1984 Corvette: Service Bulletin: Broken Window Regulator Tapes

Bulletin No: 84-3

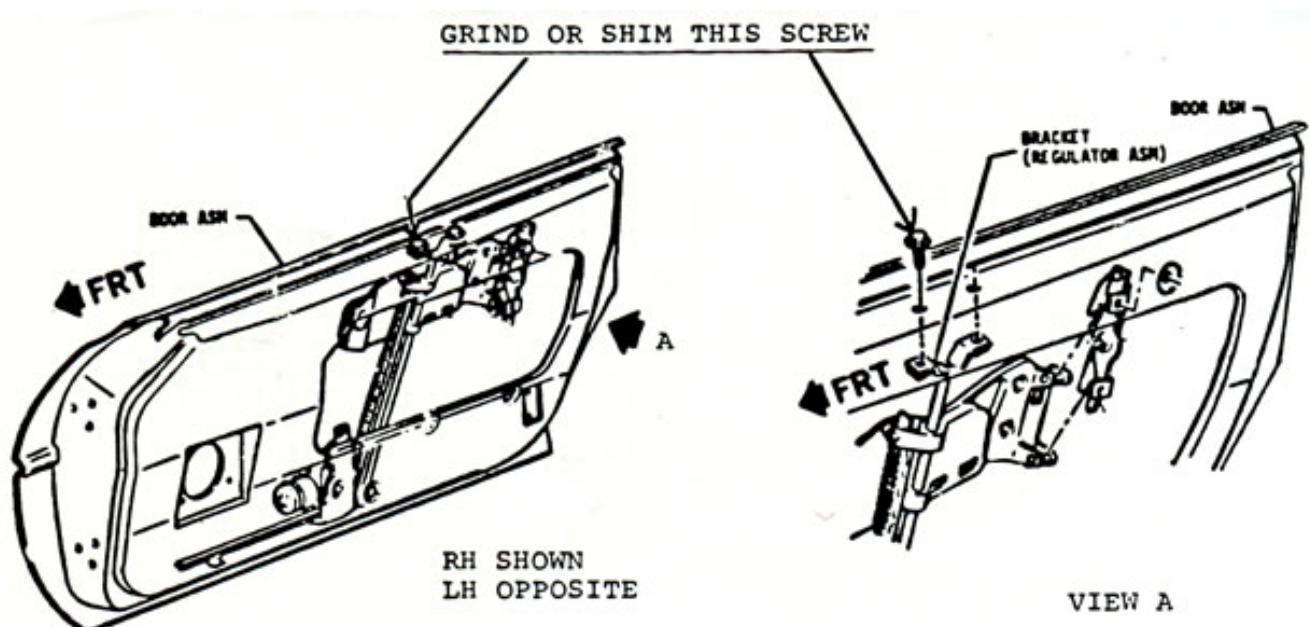
Whenever a vehicle requires service of door components, inspect for interference between the forward upper attaching screw and the upper end of the tape drive. If interference exists, one of the following options should be performed:

This is to prevent contact between the bottom of the screw and the upper end of the tape drive. If this contact exists, excessive stress is created in the tape and could cause a failure.

1. Add a washer (P/N 14038397), or equivalent, under the upper forward attaching screw (See Illustration).
2. Remove the forward attaching screw (P/N 11503800) and grind approximately 3mm from the threaded end.
